Village of Genoa, Ohio

2023 GENOA PAVING PROGRAM, CASTLE RIDGE, PHASE I

Addendum #1, February 8, 2023

MONUMENT DETAIL

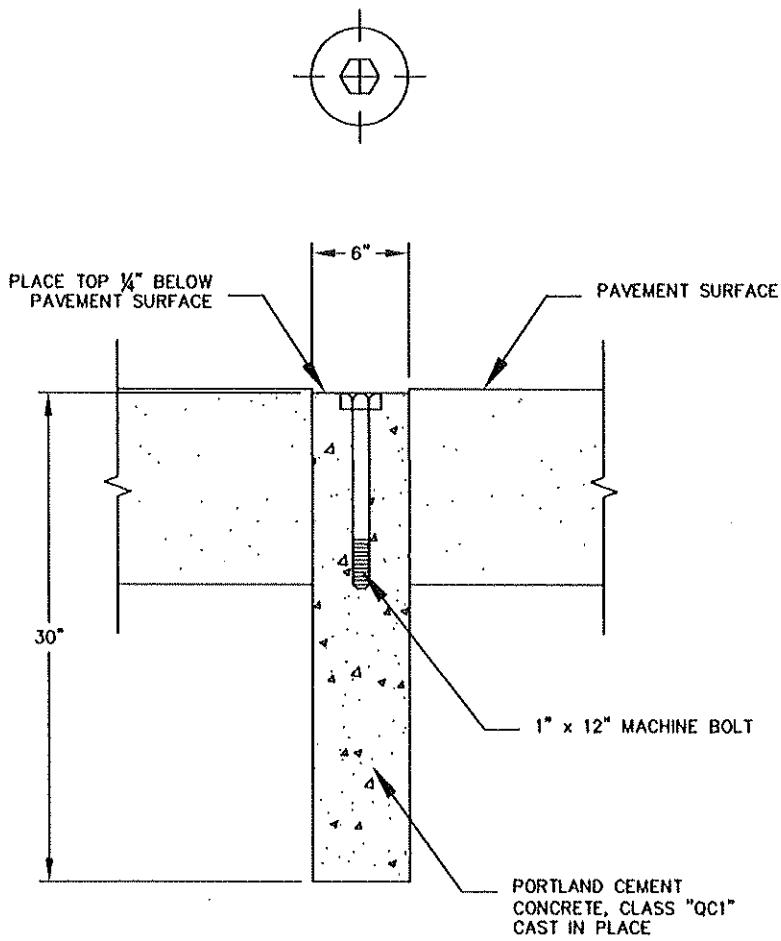
QUESTION: Regarding item 11 Monument Assembly, Ty 1 or Ty 2, is the intent to replace the monument with a monument similar to the existing monument? If not, please provide a standard drawing for the monument assembly that is requested.

ANSWER: It is the intent of the project to replace the monuments with a monument similar to the existing monuments. Detail provided on the next page. Attached to this addendum is a new bid sheet, replacing "Monument Assembly, Ty 1 or Ty 2" with "Monument Assembly, As Per Plan."

CONCRETE MONUMENT

A CYLINDRICAL CONCRETE MARKER AS DESCRIBED UNDER TYPE A EXCEPT THAT A MACHINE TYPE IRON BOLT (WITHOUT NUT) OF ONE (1") INCH IN DIAMETER BY TWELVE (12") INCHES IN LENGTH SHALL BE PLACED IN A VERTICAL POSITION WITH THE HEAD OF THE BOLT UPWARD AND LEVEL WITH THE SURFACE OF THE PAVEMENT. A POINT SHALL BE MARKED ON THE HEAD OF THE BOLT TO INDICATE THE EXACT POINT REFERRED TO ON THE FINAL PLAT.
